Addendum No. 1

April 2, 2025

**City Project No.: 23-067, Package 2
Roads Program Capital Improvement Project**

Delete sheets DM-3, L-1, L-3, CD-7, G-3, DU-1, DU-3, UUD-1, UUD-3, and TH-1 and replace with attached sheets DM-3, L-1, L-3, CD-7, G-3, DU-1, DU-3, UUD-1, UUD-3, and TH-1 of this addendum.

2 TH-1 CONSTRUCTION FUNDING SIGN

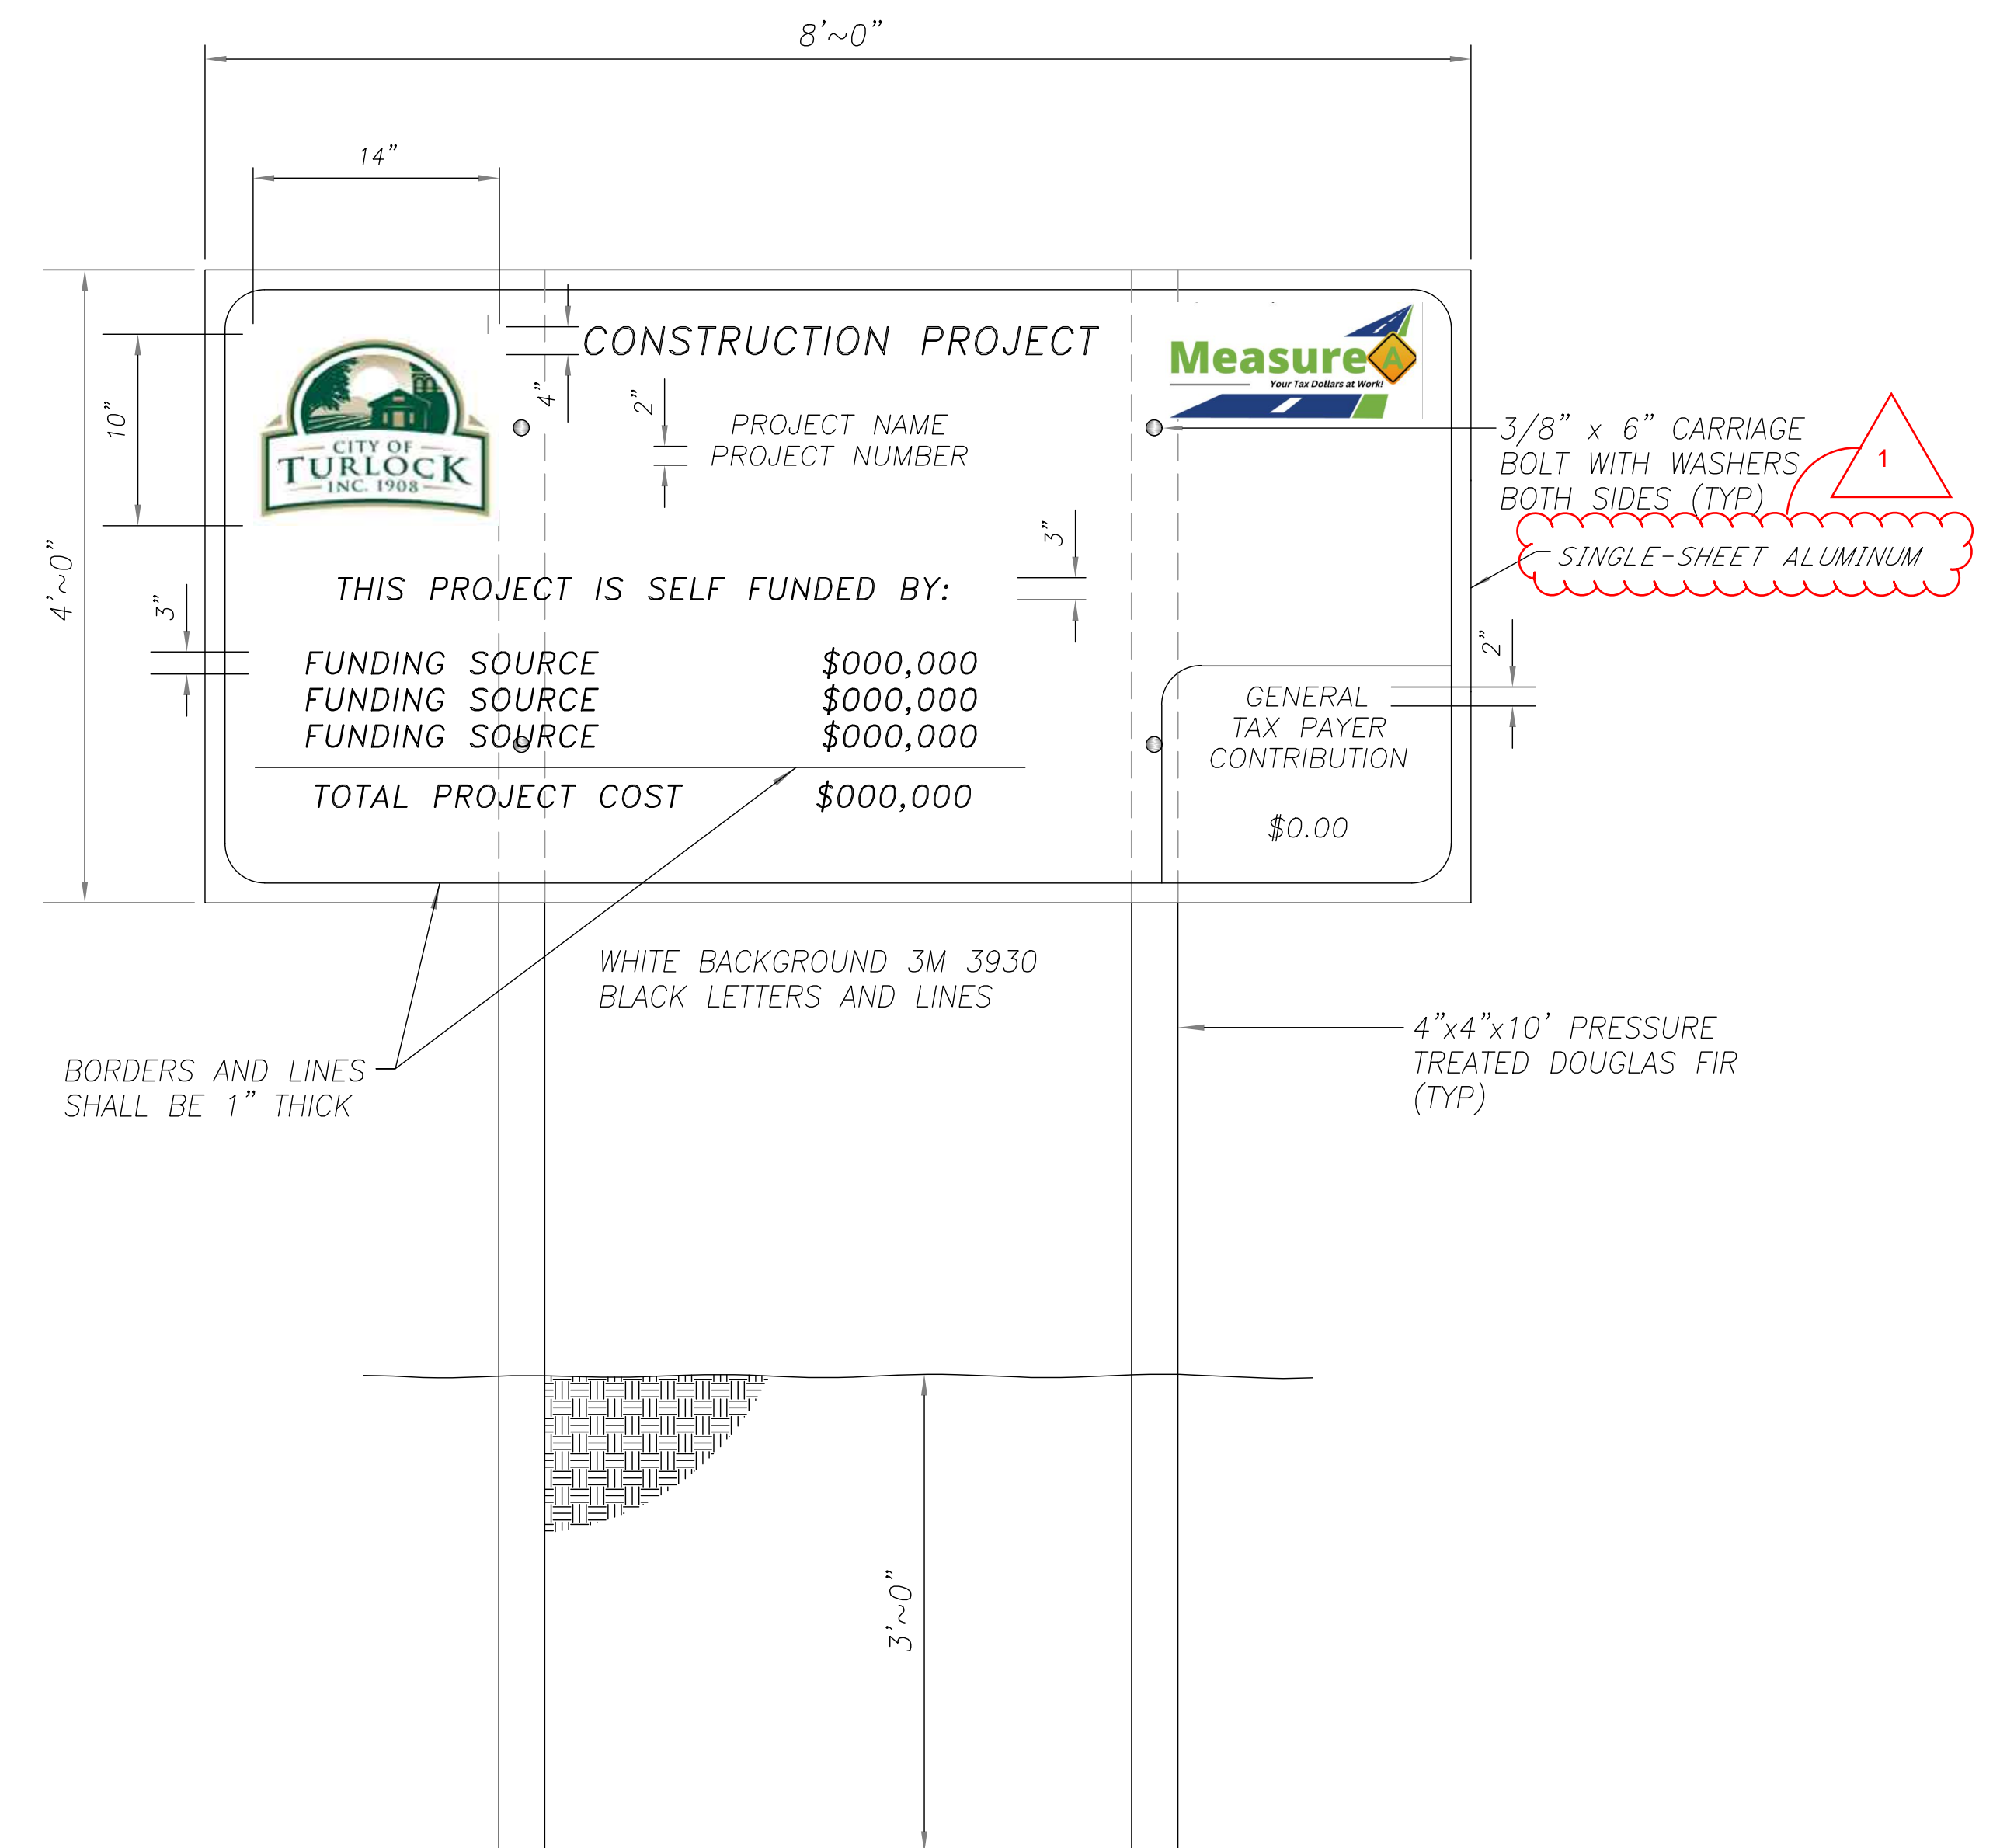
Revisions consist of various items that clarifies callouts, handling of shallow utilities, sidewalk adjustments, and funding sign detail at the intersection of Peacock/N. Johnson.

15. CONSTRUCTION FUNDING SIGN PLACEMENT TO BE DETERMINED BY THE ENGINEER
16. STREET CLOSURES AND DETOURS WILL NOT BE NECESSARY FOR THE PLACEMENT OF THE TEMPORARY HMA IN THE 2' SAWCUT AREAS. THE CONTRACTOR SHALL KEEP STREETS OPEN TO TRAFFIC WHILE THE TEMPORARY HMA IS BEING PLACED.
